City of Mississauga Department Comments

Date Finalized: 2024-01-24	File(s): A65.24 Ward: 3
To: Committee of Adjustment	
From: Committee of Adjustment Coordinator	Meeting date:2024-02-01 1:00:00 PM

Property Address: 4296 Claypine Rise

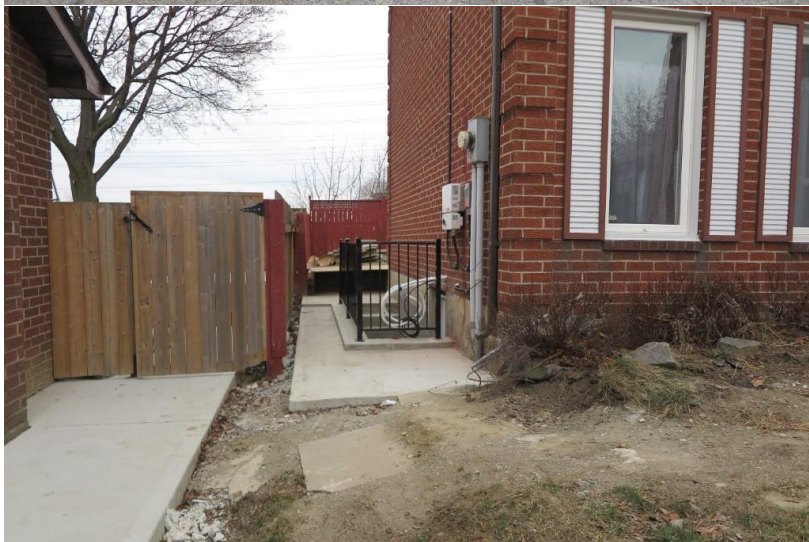
Enclosed for Committees reference are a number of photos depicting the subject property. Acknowledging that a driveway width variance is not being requested, we do have a concern with the easterly limits of the widened driveway due to any vehicle backing out into the roadway could collide with the existing fire hydrant within the boulevard area. We would recommend that modifications be made to re-instate the portion of the driveway in this area which would allow for the safe egress of any vehicle backing out onto Claypine Rise.

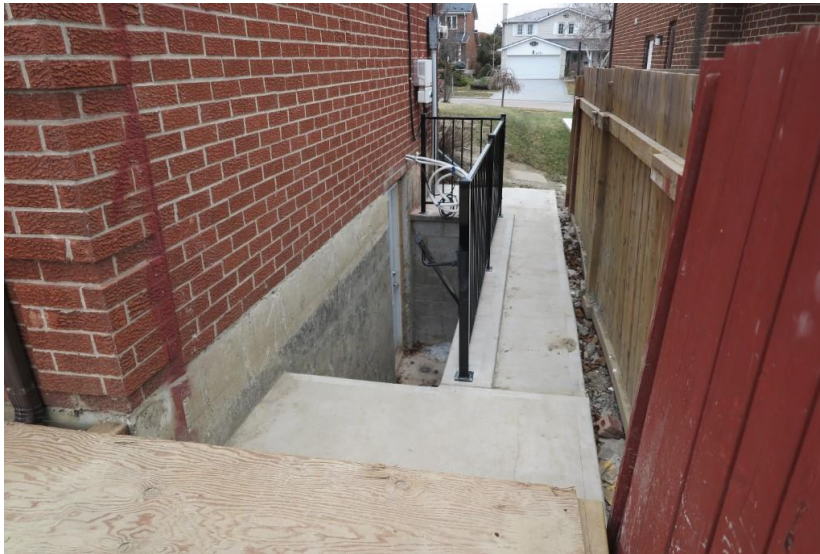
Variance #2 is requesting a 0.32 (1.05ft) south-easterly side yard setback to the constructed below grade stairwell. From our site inspection and enclosed photos we note that the owner has placed a fair amount of excavated earth in the rear yard impeding the drainage pattern and the drainage flow which was designed to be directed towards the front of the dwelling via the side yard drainage swale. We are uncertain if any further regrading is proposed in this area to alleviate this concern or if there have been any drainage related concerns identified by the abutting neighbour.
